HISTORIC AND DESIGN REVIEW COMMISSION

HDRC CASE NO: 2022-190
COMMON NAME: Hemisfair Blvd ROW
LEGAL DESCRIPTION: NCB 13814 BLK 3 LOT S IRRG 280.84 FT OF E 616.45 FT OF W 948.8 FT OF 12
ZONING: D, H
CITY COUNCIL DIST.: 1
DISTRICT: Hemisfair Historic District
APPLICANT: Miranda Garrison/City of San Antonio
OWNER: CITY OF SAN ANTONIO
TYPE OF WORK: ROW Improvements
APPLICATION RECEIVED: March 10, 2022
60-DAY REVIEW: Not applicable due to City Council Emergency Orders
CASE MANAGER: Rachel Rettaliata

The applicant is requesting a Certificate of Appropriateness for approval for right-of-way modifications to Hemisfair Boulevard.

DETECTABLE WARNING PAVER DETAIL
 N.T.S.

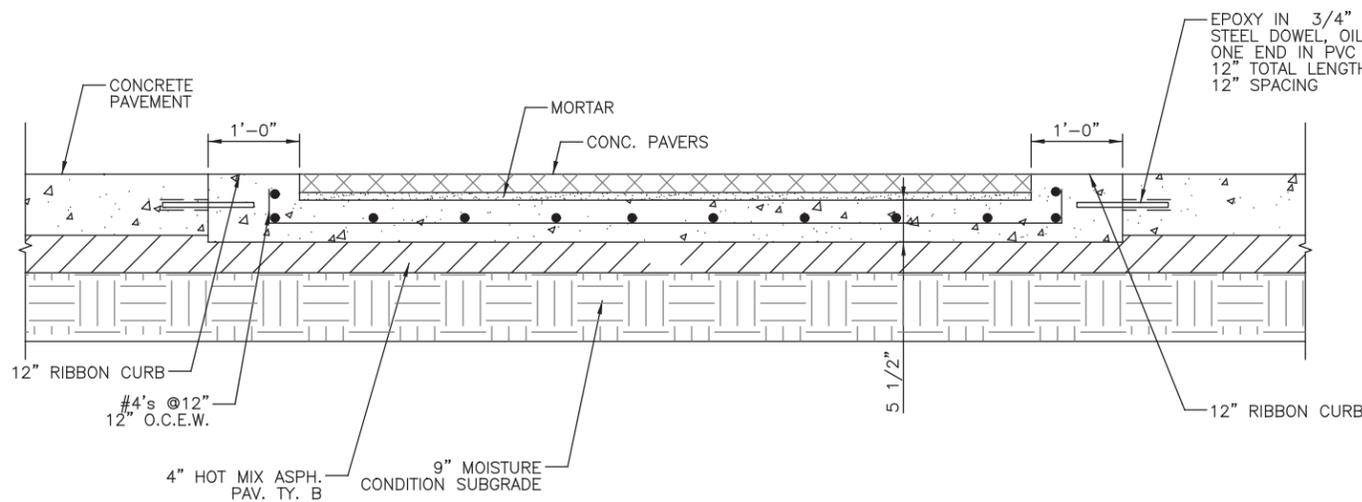
- f. ADA MODIFICATIONS – The applicant has proposed to install truncated dome panels in the form of detectable warning pavers. Staff finds that the applicant should install truncated dome panels to match the existing truncated dome panels in the district.
